City of Santa Barbara California

PLANNING COMMISSION STAFF REPORT

REPORT DATE: January 26, 2006
AGENDA DATE: February 2, 2006
PROJECT ADDRESS: 709 Wentworth Avenue (MST2004-00526)
TO: Planning Commission
FROM: Planning Division, (805) 564-5470
 Jan Hubbell, AICP, Senior Planner *JH*
 Kathleen Kennedy, Assistant Planner *KK*

PROPOSED SITE PLAN
SCALE: 1/8"=1'-0"

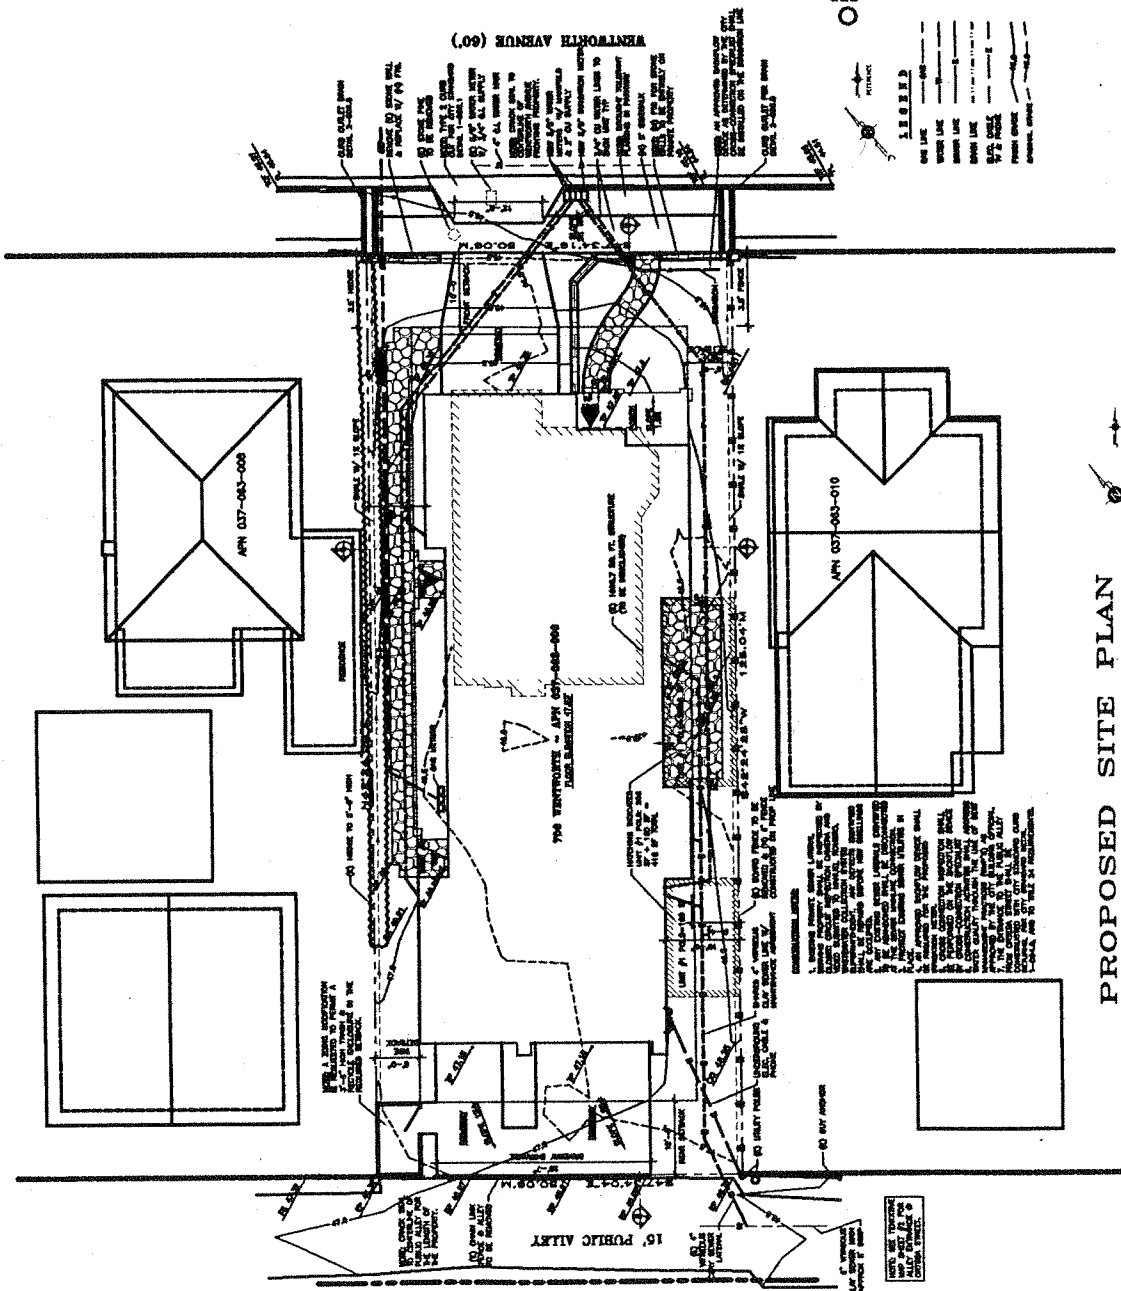
Rear and Interior Yard Setback Modifications: A trash and recycling enclosure, proposed for the southwest corner of the site, would be located in the rear and interior yard setbacks; therefore, a modification is required. The location, adjacent to the public alley, would allow for easy accessibility for trash and recycling pick up.

- Motion: Continued indefinitely to the Planning Commission with the following comments: 1) The Board finds that the applicant has largely addressed the Board's concerns for size, bulk and scale. The project has been articulated per the Board's request, particularly with roof manipulations and window treatments on the side elevations. 2) The Board is still concerned with the extensive balcony overhang at the rear of the building at the alley; which requires reduction and traditional detailed support elements. 3) The Board prefers the option to bring the front porch out and away from the garage to make it a more dominant element on the front elevation. 4) The Board will be looking to see the roof line over the garage to be brought down in height to minimize its importance to the front elevation. 5) Restudy the roof line at the porch in its intersection with the deck on the second floor to bring the juncture of the hip to the juncture to the proposed deck corner. 6) The Board looks forward to the front windows and doors to be wood clad or higher quality. 7) The Board accepts the use of vinyl windows along the remaining elevations. 8) The Board appreciates the applicant's value concern for the existing front site wall and the reuse of the stones in a new configuration. 9) The Board understands that the stone work will continue on the western side of the driveway.

Motion: Continued indefinitely with the following comments: 1) Study the project to reduce the "boxiness" of the architecture. 2) Relieve the side elevations by finding areas to manipulate the roof forms and manipulate the continuous ridge. 3) Make significant alterations to the Wentworth Avenue elevations to assure that the porch element is more prominent than the garage face in order to maintain the bungalow charm of the original project.

Motion: Indefinite continuance to the Planning Commission with the following comments: 1) The Board is comfortable with the style as presented, i.e., shingles above, bevels siding below, wooden trim elements, general simplicity of the front porch that addresses the street. 2) The Board is uncomfortable with the massing and is particularly concerned with the east and west elevations, but is sensitive to what the Planning Commission would be looking at in terms of density with this the neighborhood, which has a direct relation to massing. 3) The Board recognizes that the best neighborhood examples are similar to the proposed style of architecture, but however involve one-story buildings facing the street, porches, and no garage. 4) The Board is concerned about the changing visual aesthetics of the neighborhood with a garage that faces Wentworth Avenue, but recognizes that has a severe impact on how the applicant could develop the site and its density. 5) The widest part of the proposed building appears to right on Wentworth Avenue, which changes the rhythm of the neighborhood. 6) The native stone wall in the front is reused and preserved. 7) There is ample space on the east and west side for small canopy trees.
